Re: Docket 317 – The United Illuminating Company Application for a Certificate of Environmental Compatibility and Public Need for the construction, maintenance, and operation of a proposed 115-kV / 13.8-kV electric substation and associated facilities at 3-7 Wildflower Lane, Trumbull, Connecticut

TESTIMONY OF ROBERT E. CARBERRY
on behalf of
THE CONNECTICUT LIGHT AND POWER COMPANY

Exhibit 4.4

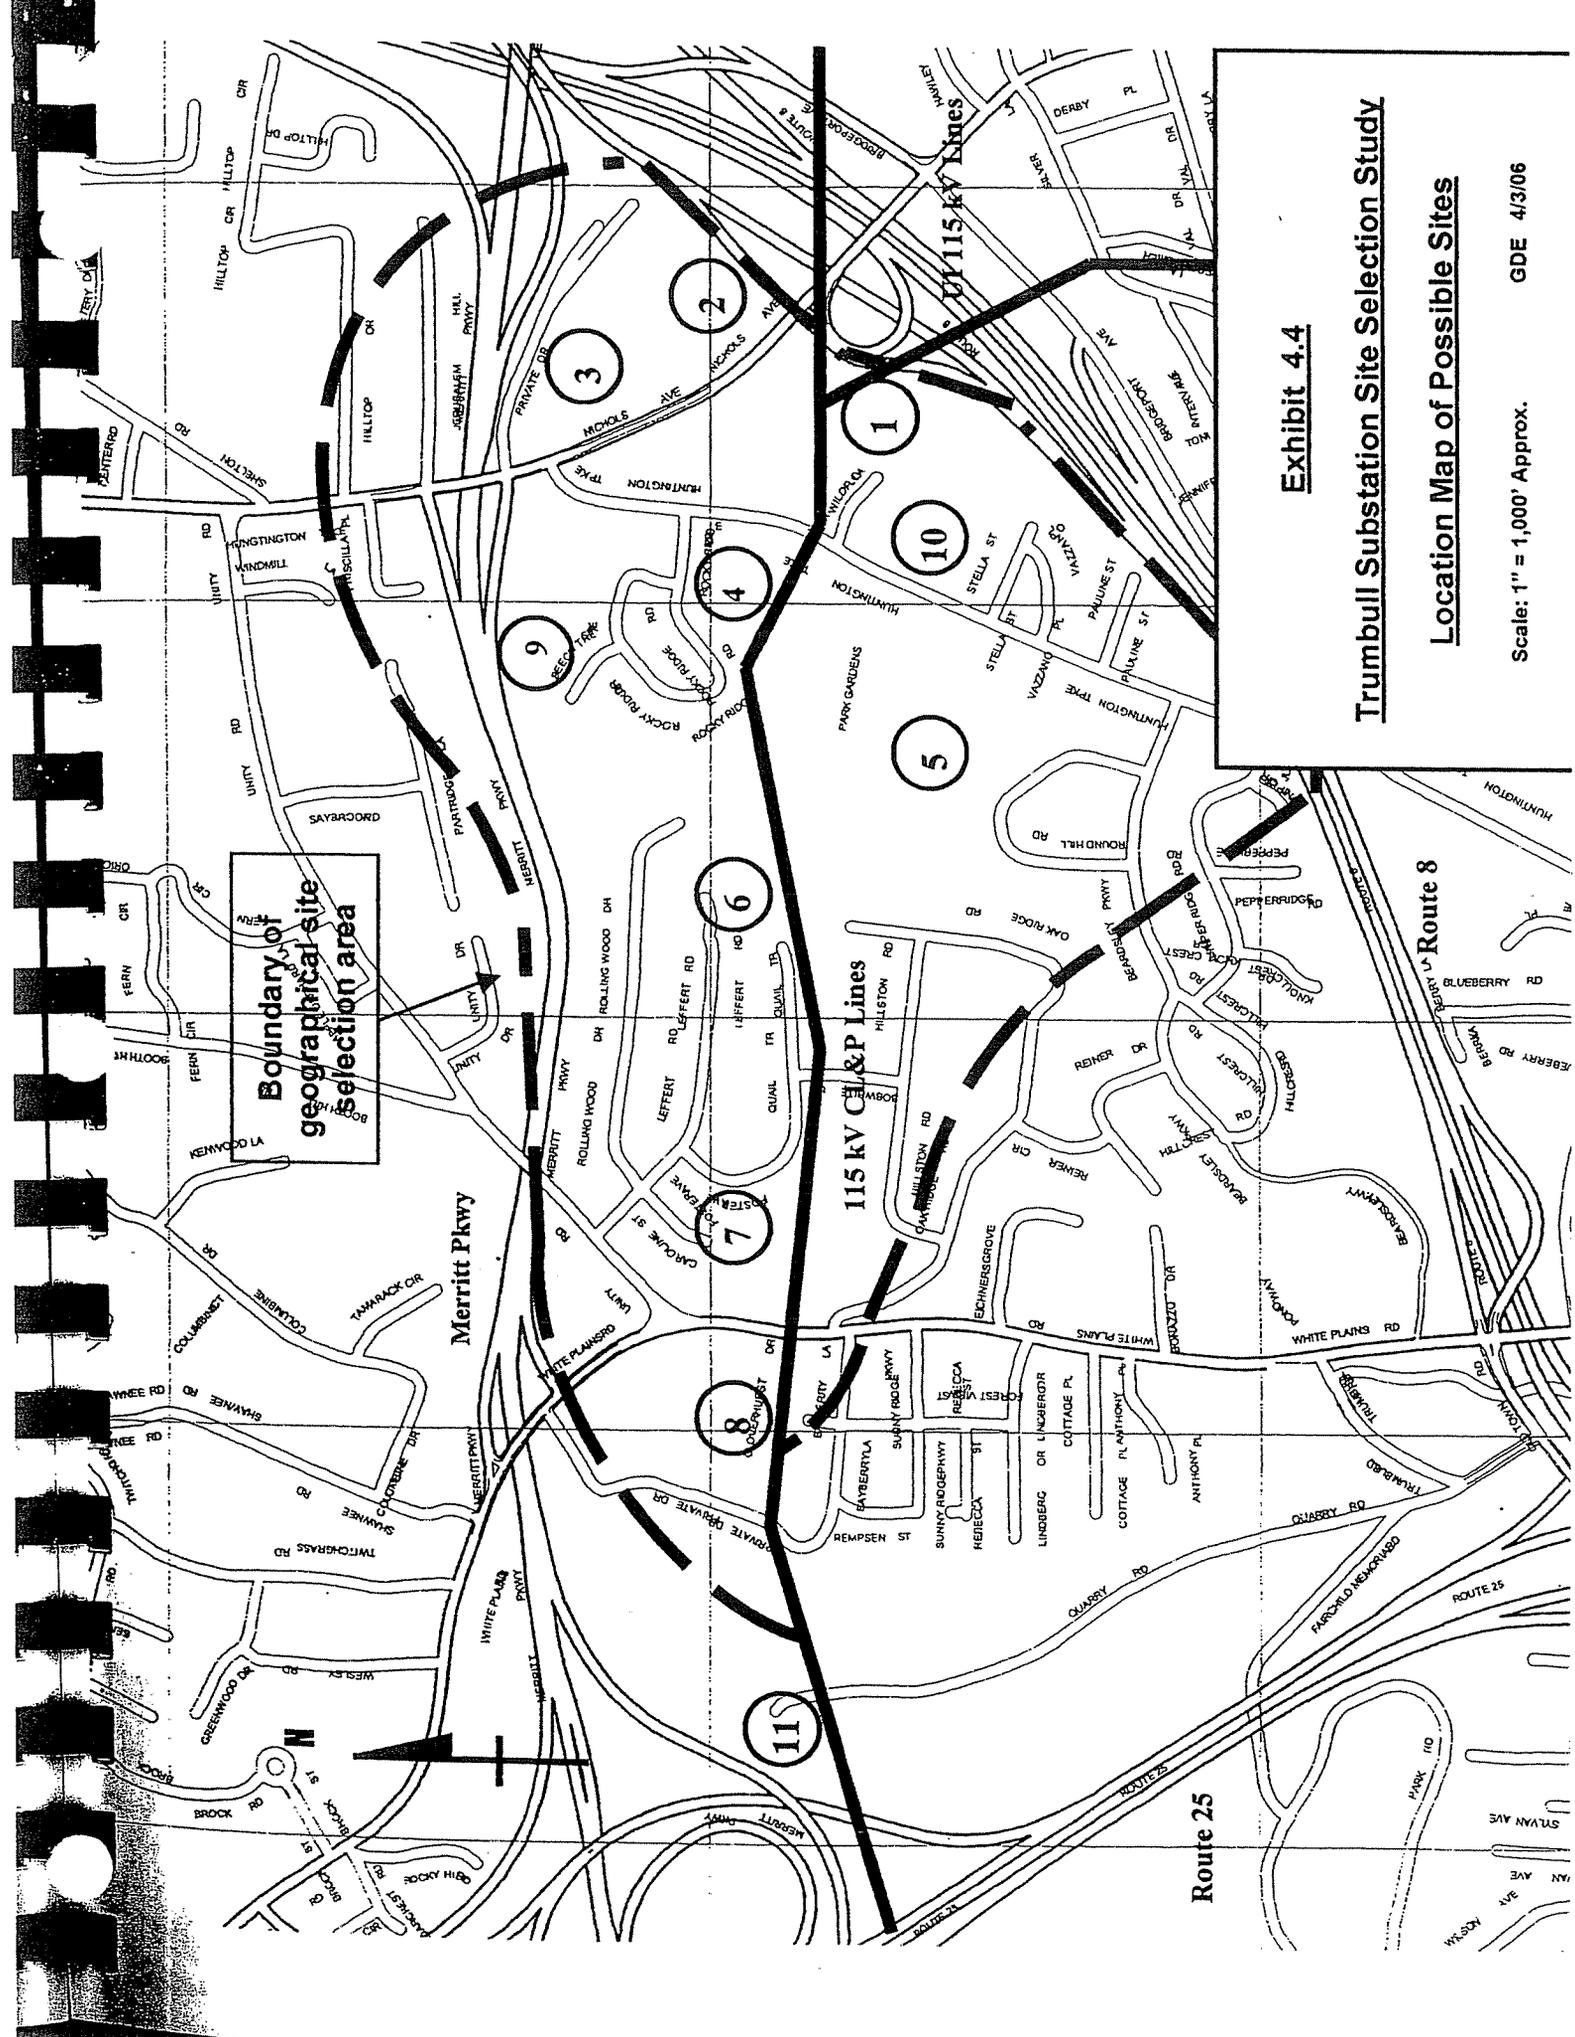
3 A. Exhibit 4.4 of UI's "Trumbull Site Selection Study" (Ex. D to the Application)
4 illustrates this relationship well. A copy of that exhibit is attached to this testimony for
5 convenience of reference. As shown there, the proposed location for the substation (Site
6 1) is at a "T" junction of UI and CL&P 115-kV lines, known as "Trumbull Junction." A
7 one-line diagram of this junction is shown in Figure 6 of the Application, at vol. 1, p. 17.
8 As shown in these figures, UI and CL&P each own segments of the 1710 and 1730
9 circuits. The UI segments extend in a generally south to north direction from UI's
10 Pequonnock Substation in Bridgeport to a Trumbull Junction (forming the stem of the
11 "T"); and the CL&P segments extend east and west from the junction (along the top of
12 the "T.") The CL&P line consists of two 115-kV circuits on common support structures.

15 A. Yes. UI proposes to break up the existing three-terminal 1730 circuit into three
16 circuits: Trumbull-Pequonnock, Trumbull-Devon and Trumbull-Weston. To do this, a
17 new connection from a CL&P-owned span of the 1730 circuit on the west side of
18 Trumbull Junction must be made to the proposed substation. At this location, the 1730
19 circuit is on the north side of CL&P's towers, and the proposed substation is on the south
20 side.
